Access Compliance Report

Public Rights-of-Way

(Curb Ramps)

Intersection ID: 4854	Main Street: FARLOW_RD	Cross Street: WADE_E_MORGAN_RD	Location: N
ADA ID: 557FB630D471	Ramp Type: Perp	Initial Pass/Fail: Fail	Overall Compliance: No
Severity Score: 13.75			
Codes/Mitigation Info/Possible Solution		Field Measurements/Component Compliance

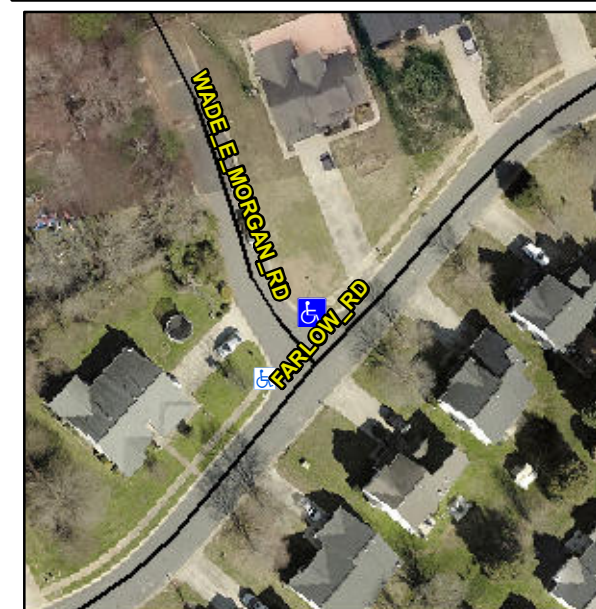
Not Found, R304.2.2, R304.5.3

Compliance	Description	Data	Compliance	Description	Data
N/A	Ramp Length (in)	51.0	No	Ramp Slope (%)	11.6
Yes	Ramp Width (in)	48.0	No	Ramp XSlope (%)	2.8
N/A	Flare Type LT	N/A	N/A	Flare Type RT	N/A
N/A	Flare Slope LT (%)	N/A	N/A	Flare Slope RT (%)	N/A
N/A	Flare Traversable LT?	N/A	N/A	Flare Traversable RT?	N/A
N/A	Landing Length (in)	N/A	N/A	DWS Provided?	N/A
N/A	Landing Width (in)	N/A	N/A	DWS Contrast?	N/A
N/A	Landing Slope (%)	N/A	N/A	DWS Length (in)	N/A
N/A	Landing X Slope (%)	N/A	N/A	DWS Full Width?	N/A
N/A	Landing Curb? (Y/N)	N/A	N/A	DWS Offset (in)	N/A
N/A	Shared Landing?	N/A			
N/A	Gutter Ponding?	N/A	N/A	Gutter Slope (%)	N/A
N/A	Gutter Lip Ht (in)	N/A	N/A	Gutter X Slope (%)	N/A
N/A	Painted X Walk1?	No	N/A	Painted X Walk2?	N/A
	X Walk 1 Direction	To SW		X Walk 2 Direction	N/A
N/A	X Walk 1 Width (in)	N/A	N/A	X Walk 2 Width (in)	N/A
	X Walk 1 Slope (%)	1.7		X Walk 2 Slope (%)	N/A
	X Walk 1 X Slope (%)	1.6		X Walk 2 X Slope (%)	N/A

Possible Solutions:

Remove & Replace Entire Ramp.
